URANERZ U.S.A., INC.

WDEQ-LQD Permit #9RD
USNRC Amendment

URANERZ U.S.A., INC.	
RUTH ISL PILOT PROJECT	
PROPOSED STABILIZATION	
MONITORING WELLS	
SCALE: 1" = 20'	DATE: 8/15/83
DRAWN BY: J.S.	CHECKED BY: J.S.

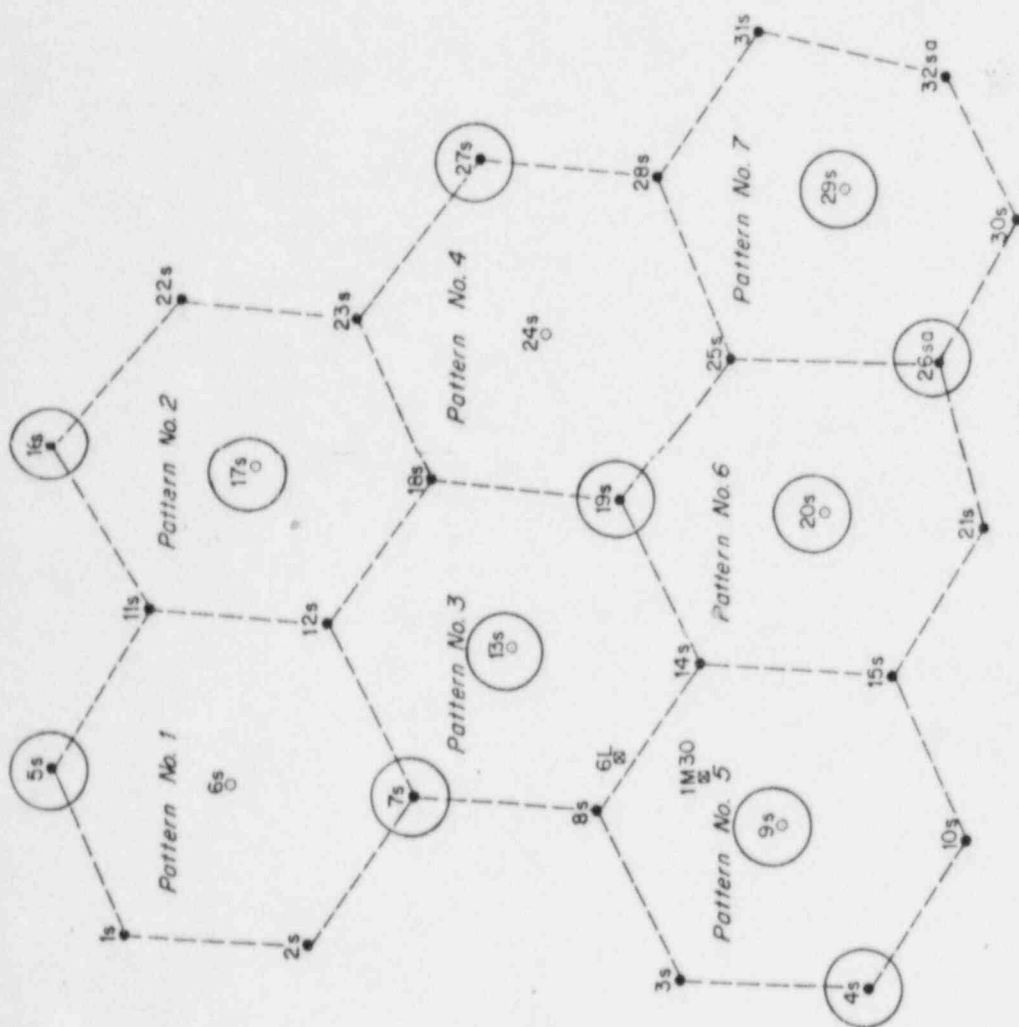
(3) Well Field Sampling - Attached to this letter is a drawing of the wellfield and a new mix of recovery and injection wells to be sampled. This new pattern is one that both the environmental and operational staff of UUS feel will supply sufficient data to indicate the success of restoration.
